MODIFICATION REQUEST:

***Concept Approval for redevelopment of the
Former Allied Mills Flour Mill Site***

MP10_0155 MOD 1

***Modifications to building envelopes, dwelling
numbers, land use mix, parking, and affordable
housing.***

Figure 11: Building 1A as approved

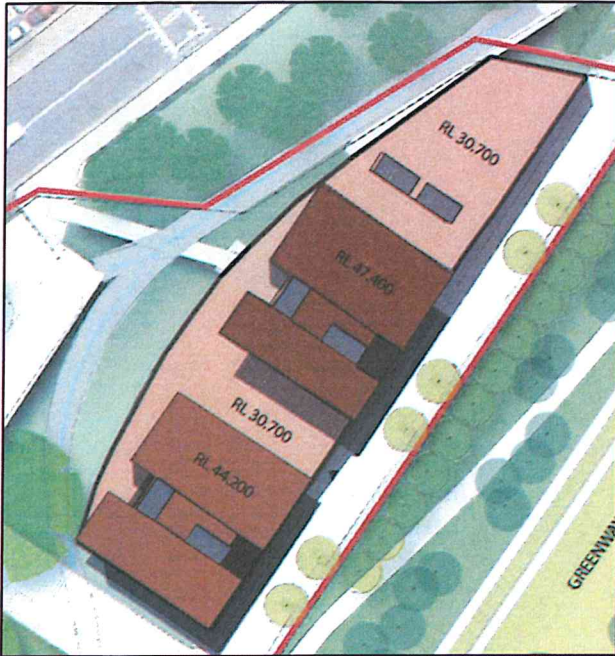
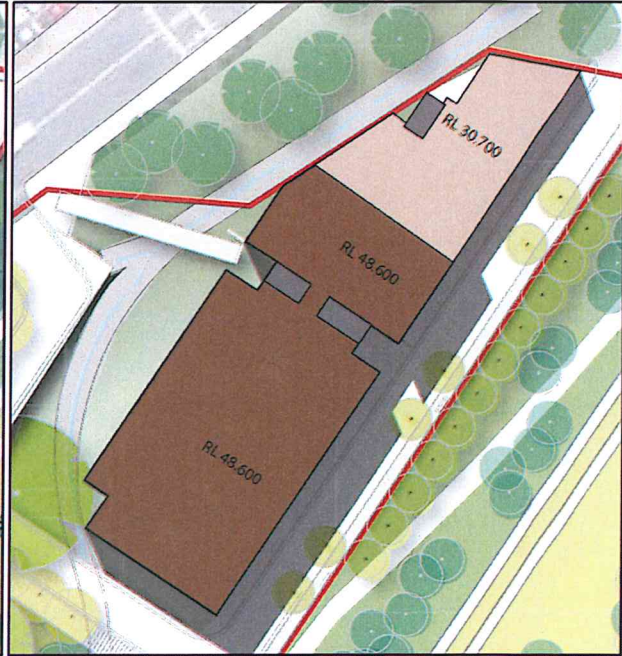
The proposed modifications to Building 1A include replacing the two approved tower forms with a single long block built form, increasing the maximum height by between 1.2m and 4.4m (1 storey) above the height of the approved tower heights, and amending the building footprint and increasing building depth, particularly at the upper floor levels as shown in **Figures 11 and 12**.

The building envelope is located within the Marrickville Council LGA. Marrickville Council raised concerns that infilling the space between the two towers, creating a uniform 11 storey building and removing the amount of indentation will create an unrelenting horizontally dominant building wall form. Council are concerned that this undermines the original intent of the building to respond to other existing industrial structures on the site which have a vertical emphasis. Further, the proposal will create an imposing bulky form which will visually dominate the overall development and low density residential surrounds. Council made suggestions to improve the design including incorporation of indents in the plan to break up the building form and reducing the height of the 'filled in' space to be at least a storey lower than the envelopes either side.

Ashfield Council also raised concerns about the increased height and bulk, with Council officers noting that the proposed modifications result in the building appearing as one large monolithic block.

Following exhibition of the modification request, the Department wrote to the proponent, raising concern with the proposed change from two tower forms with vertical emphasis to a single large upper element resulting in impacts of visual bulk.

In response the proponent reduced the envelope of the upper levels by increasing the setback from Longport Street to the north by 4.2m. In addition the RtS included a new statement of commitment to guide the future detailed design of the building. The commitment provides architectural and urban design guidelines in relation to building form, materials, architectural detail and design excellence to ensure that:

Figure 15: Building envelope section (source: Proponent's RtS)

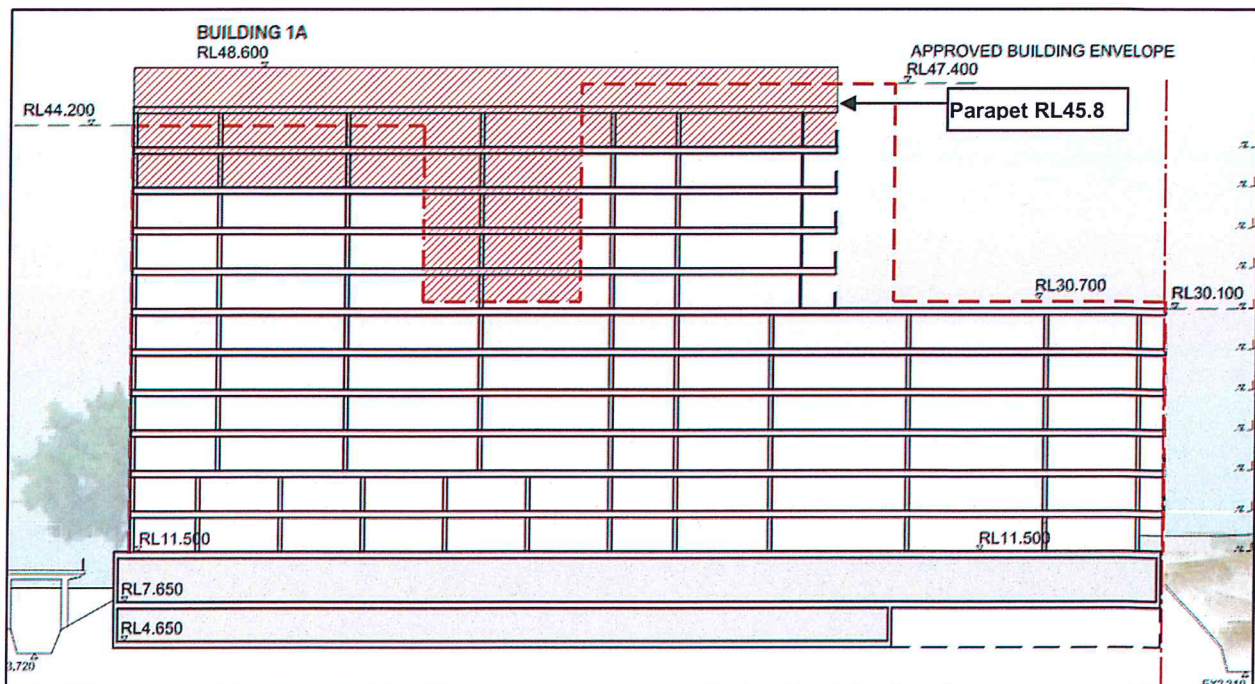
It is proposed to increase the maximum height of the building to RL48.6, but as shown in **Figure 15**, the parapet height is likely to be in the order of RL45.8. Therefore, while the maximum height would be 1.2 metres higher than the previously approved maximum height of the building (RL47.4), the parapet height would be around 1.6 metres lower than the previously approved maximum height.

At 11 storeys, the building will present as one storey taller than the nearby future buildings on Lewisham Estate (approved for 10 storeys), similar in height to the six pack of silos (approved as 11 storeys) and 3 storeys smaller than the 4 pack of silos (sought to be 14 storeys under this modification).

On this basis, the Department is satisfied that, subject to a future building adopting a parapet height no greater than RL45.8, and the plant above the parapet not being readily perceptible, the visible building height will be similar to that of the approved envelopes and would therefore be acceptable. The Department therefore recommends a future assessment requirement requiring that the parapet height not exceed RL 45.8. The future assessment requirement also requires that the plant and lift area be setback at least five metres from the main building facades and three metres from the recessed building facades to ensure that the plant does not make a material contribution to visible building height or bulk.

Figure 16: Potential floor plan adopting an additional indentation

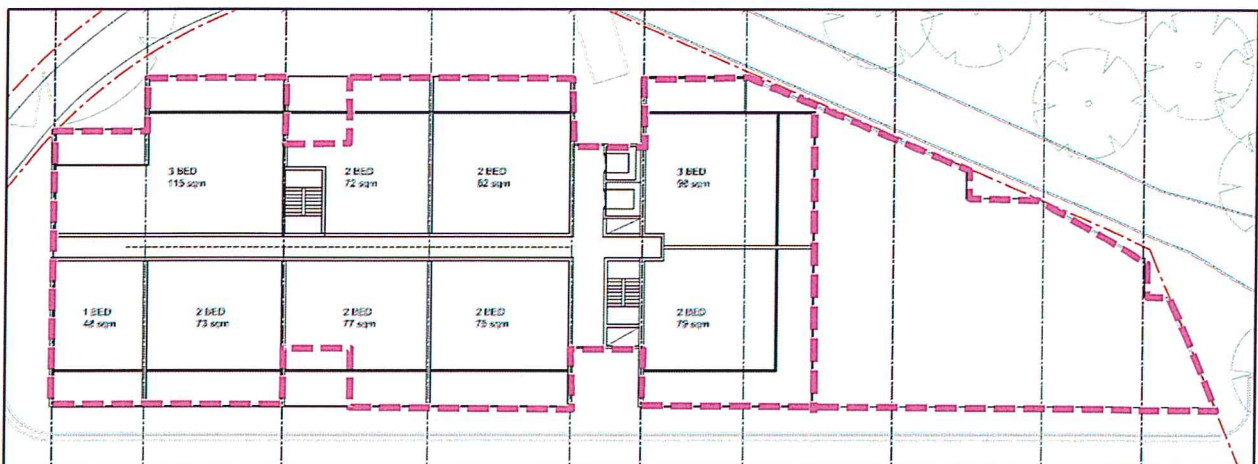
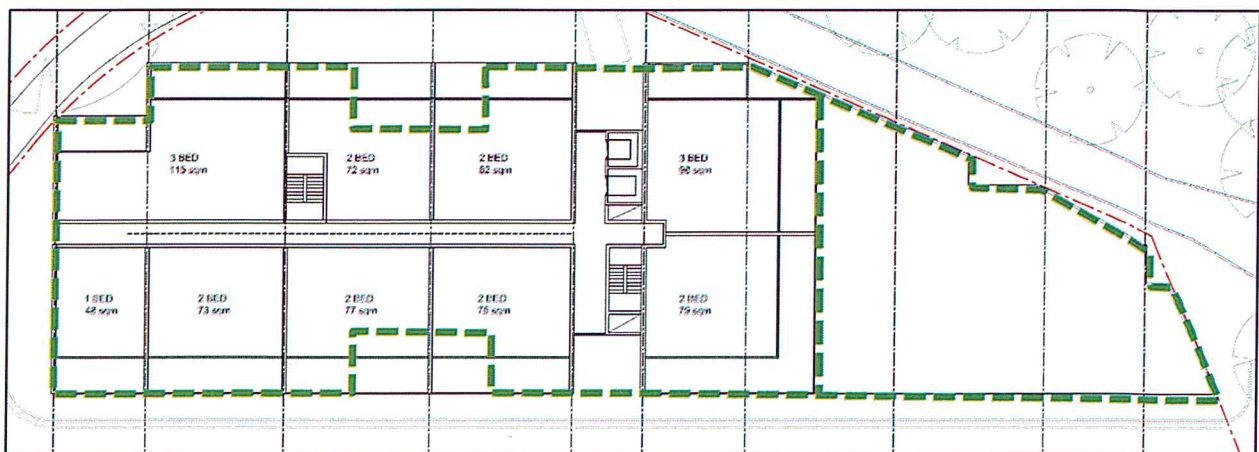
The Department's key concern is the visual impacts resulting from the bulk and scale of the future building. In particular, the length of the façade and horizontal emphasis. The existing former industrial buildings on the site to be retained, including the Mungo Scott and silo buildings, have a strong vertical emphasis and it is important that Building 1A respects and relates to these buildings.

The proponent has sought to reduce visual bulk and provide interest with a five metre wide indentation in the floor plan proposed towards the northern end of the building (**Figure 13**). This assists with providing vertical emphasis and breaking up the massing in this section of the building envelope, but the southern section of the envelope retains an unbroken form over 36 metres in length.

The Department is of the view that further articulation would be required to reduce the bulk of the southern section of the building. In addition to other architectural detailing, this could be potentially achieved by an additional recess towards the south or otherwise a larger, centrally located recess as depicted in **Figures 16 and 17**.

Notwithstanding, the final building form will be subject to assessment in a future Development Application by Marrickville Council, which the Department notes also includes a formal design review process. The Department therefore recommends that a future assessment requirement be imposed requiring that the future Development Application for Building 1A include further

articulation of the building to ensure an appropriate visual relationship with other buildings on the site. This may reduce the overall GFA yield of the building.

Figure 18: Buildings 3A & 3B as approved

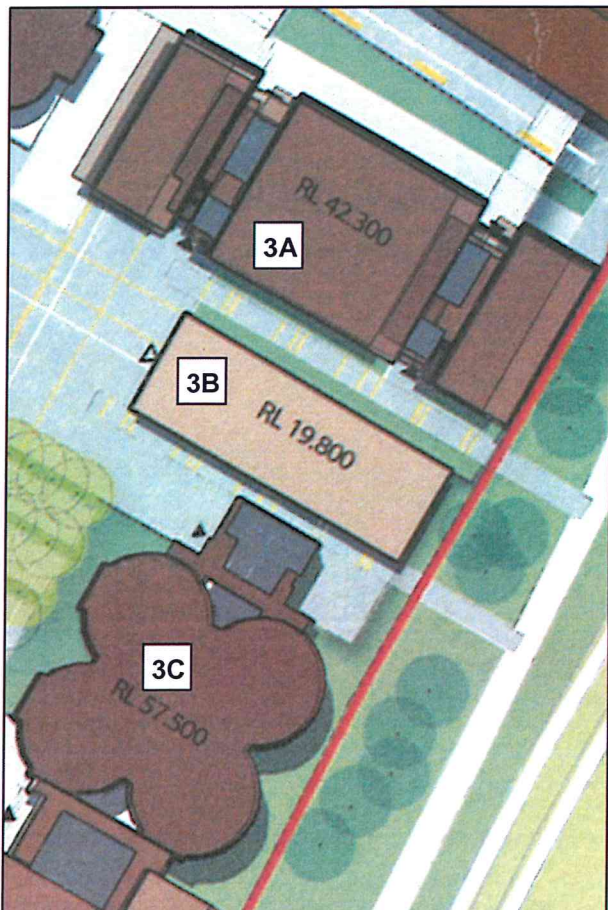
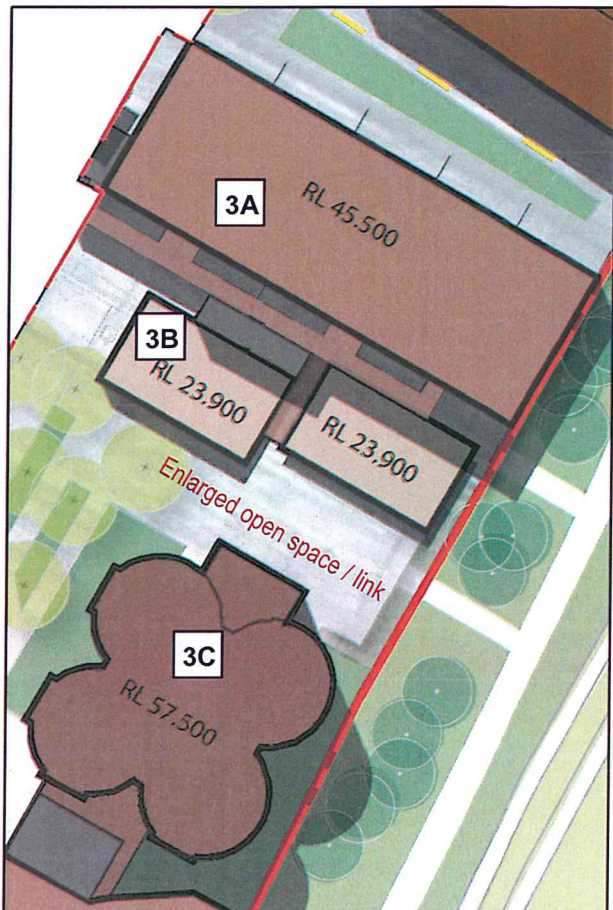
The proposal seeks to increase the height of the envelope of Building 3A by 3.2m to allow for a 10 storey building plus plant and to increase the height of Building 3B by 4.1m to allow for a 4 storey building. It is also proposed to add a service zone in the gap between the two buildings, essentially joining the buildings into one larger structure. In doing so, Building 3B is relocated slightly towards the north and adopts a staggered footprint. The proposed changes are shown in **Figures 18 and 19**.

The proposed increase in height to part 10 / part 4 storeys and the proposed changes to building form are acceptable in urban design terms, as:

- the building remains at least 12 metres lower in height than the 4 pack silo structure, ensuring it remains the visually dominant building on the site;

- the building is located on the eastern boundary of the site, away from the established low scale residential area to the west and appropriately relates to the scale of development in the McGill Street precinct and Lewisham Estate to the east which also include buildings presenting as 10 storeys in height to the railway corridor;
- the larger building presents as two distinct elements (4 and 10 storeys) and is capable of being sufficiently articulated so that it will not present an unacceptably bulky appearance;
- the increased footprint remains smaller than Buildings 2A and 1A to the north; and
- the loss of the gap between the two buildings is offset by the provision of an enlarged through site link to the south of the building, providing a clear visual break between in the building massing as viewed from the light rail corridor and within the site.

Figure 20: Building Separation

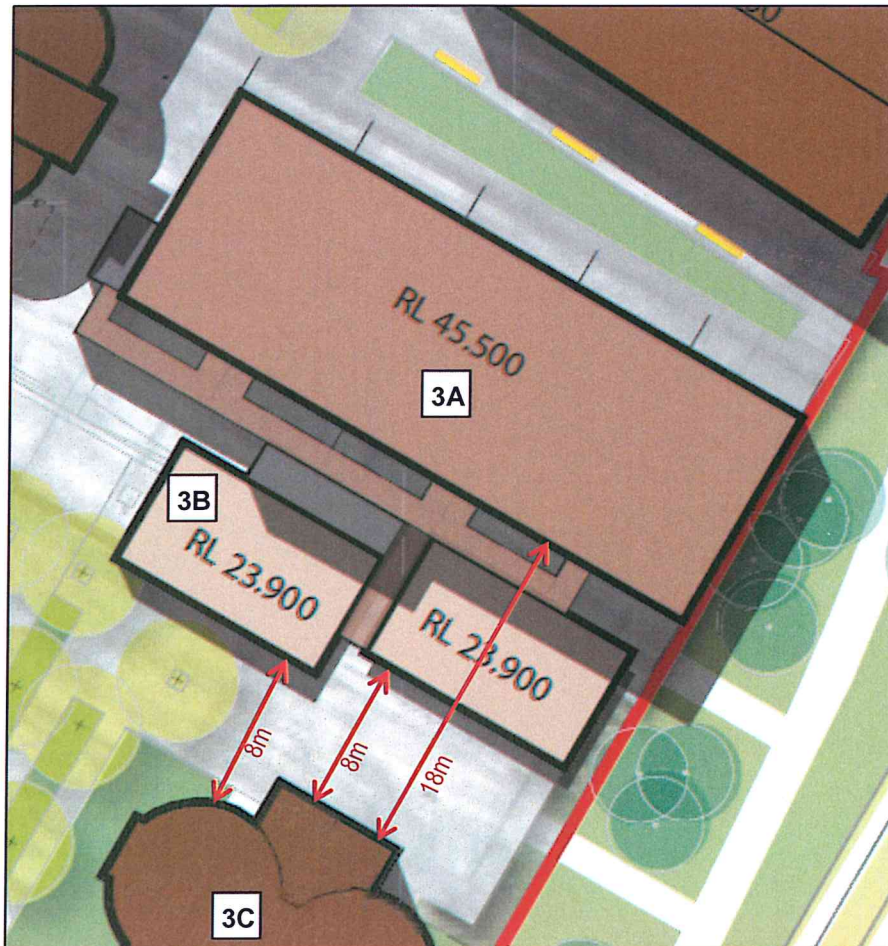
The modifications result in two changes to building separation as shown in **Figure 20**:

- Building 3A will have a separation of 18m from Building 3C (where both buildings exceed 8 storeys in height).

Despite resulting in building separation distances four to six metres less than that recommended for adjoining habitable rooms and balconies, the proposed separation is reasonable for a dense urban environment. The Department is satisfied that an acceptable level of separation and amenity can be achieved in future applications, subject to detailed design which will consider the orientation of apartments, location of non-habitable and habitable rooms and balconies, location of windows, and the use of appropriate privacy measures where necessary.

Figure 21: Approved shadows 9am 21 June

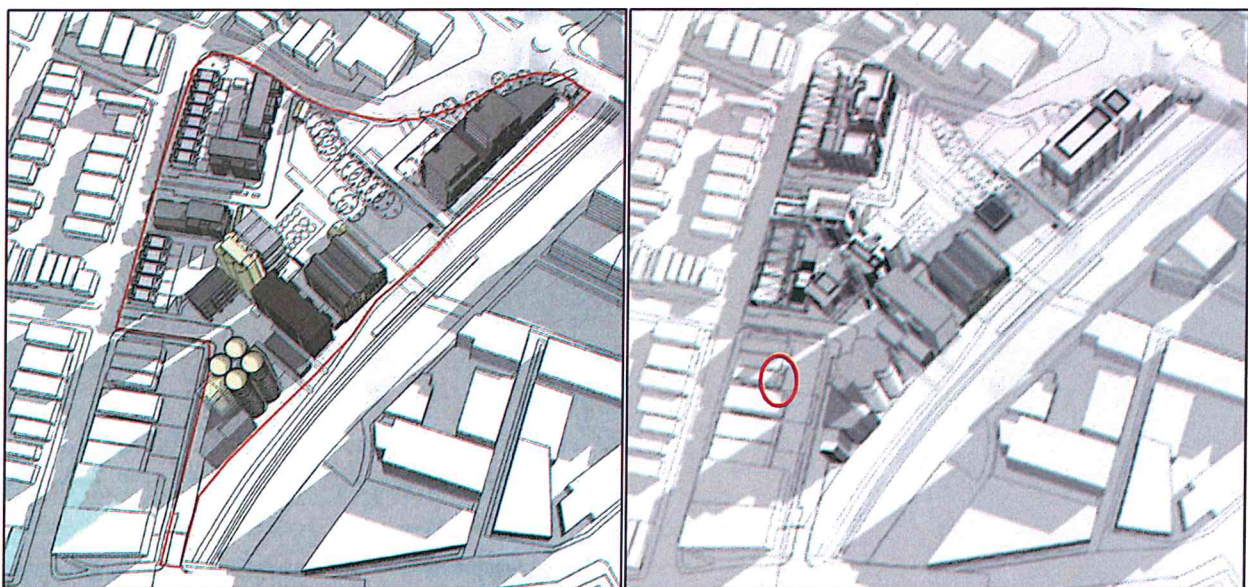
The proposed increase in the height of Building 3A by 3.2 metres will result in a small increase in overshadowing to the rear façade and rear open space of two nearby dwellings (nos 36 and 38 Edward Street) within the mixed use zone for a one hour period only, being between 9.00am and 10.00am at mid-winter. The extent of the additional shadowing is minor, as depicted in **Figures 21** and **22**. Despite the small increase in shadowing, those dwellings will continue to receive approximately three hours of solar access to their rear facades at mid-winter and in excess of two hours of solar access to the majority of their rear gardens. Given that the dwellings are located in a mixed use zone where planning controls envisage a greater level of density, and are partly constrained in that the rear facades and gardens are self-shadowed from 12.30pm, the level of solar access retained to those dwellings is acceptable and consistent with expectations for dense urban areas as set out in the RFDC and the Draft ADG under SEPP 65.
